Global Change Notification (GCN)

Product Family	Impact	10627226
		GCN Number
Series	76450 and 170026	February 06, 2014
		Date Issued

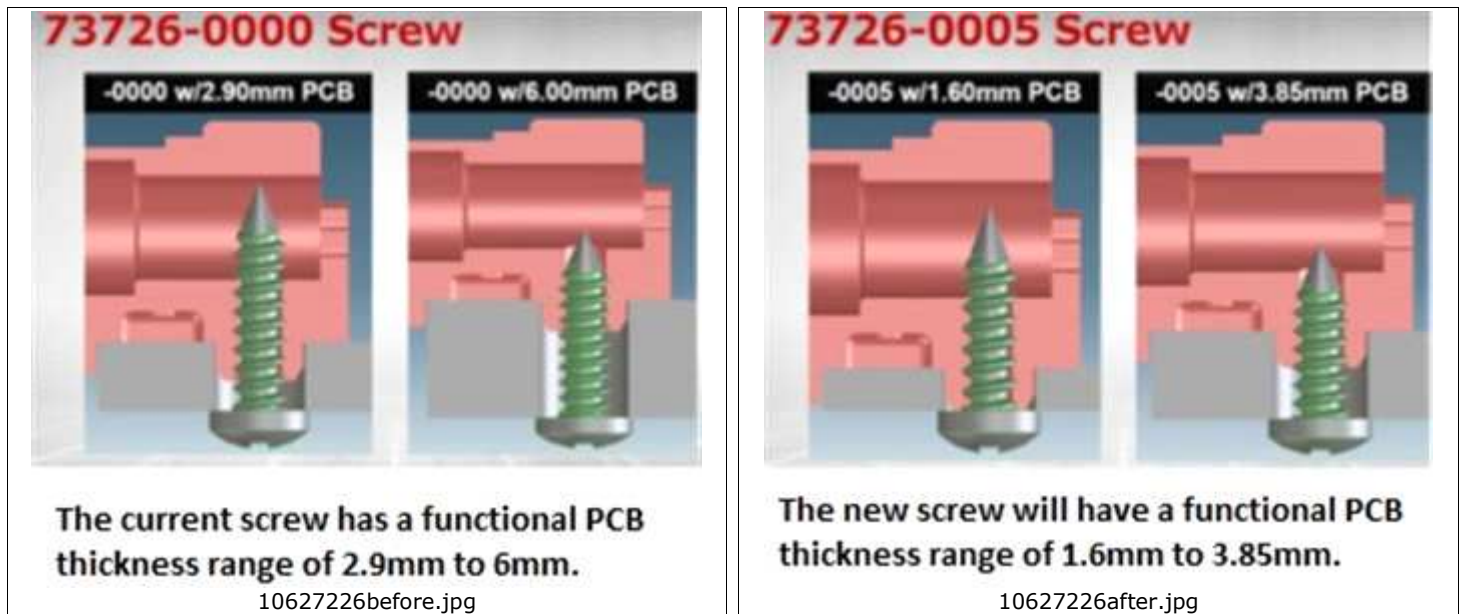
Reason For Change	Outsourcing Component Or Subcomponent
Change Description	The purpose of this letter is to inform you that Impact 100 Ohm 2 pair RAM's with integrated guide modules are currently shipped with screw part number 737260000. We are changing to a shorter screw, part number 737260005. We are making this change to accommodate applications that have PCB's at or close to the miminum PCB thickness specified for the 2 pair RAM, which is 1.6mm. The functional PCB thickness range of 1.6mm-3.85mm will be specified on the sales drawing. QN#: 10622040
